VERIFICATION REPORT

Project Title	Xinjiang Kaiduhe River Chahan Wusu Hydropower Project
Version	Version 01
Report ID	A+SH_SYST_01312 VCS

Report Title	Verification report of a VCS project
Client	Europe New Energy Investment Capital Limited
Pages	30
Date of Issue	19-12-2012
Prepared By	LGAi Technological Center, S.A.
Contact	Address: Ctra. Accés a la facultat de Medicina, s/n Campus UAB, E - 08193 Bellaterra (Barcelona) – Spain Tel.: +34 935 672 008 Website: www.appluscorp.com Email: simon.shen@applus.com
Approved By	Miquel Sitjes Cabanas 
Work Carried Out By	Team Leader/Lead Auditor: Denny Xue Auditor: Simon Shen

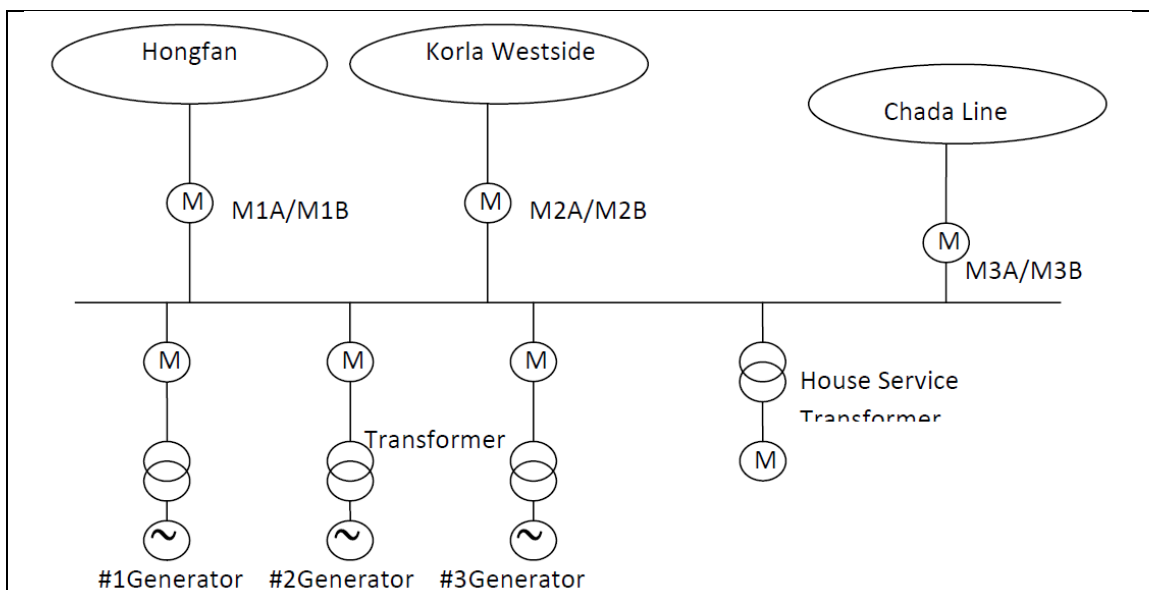
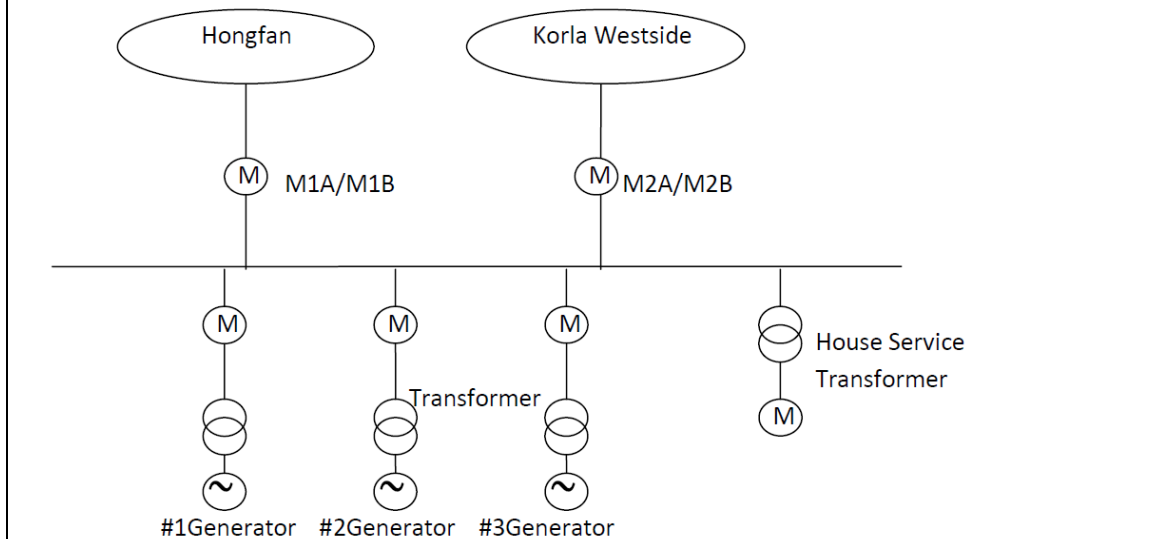
Type:	☒ CAR ☐ CL ☐ FAR	Number:	#1
Raised by:	Meng (Simon) Shen	Ref. to MR	Section 3.3
Description of the audit finding		Date:	12/09/2012
It's described in the MR version 01 that the monitoring diagram is as below:

As confirmed with the project owner that the meters M3A/M3B are not applicable during the monitoring period. Thereby pls. Change the monitoring diagram accordingly.

The monitoring diagram has been revised as below:

The revised monitoring diagram reflects the real practice thereby is accepted.		
Conclusion by Lead Auditor	Date:	18/12/2012
Closed out.
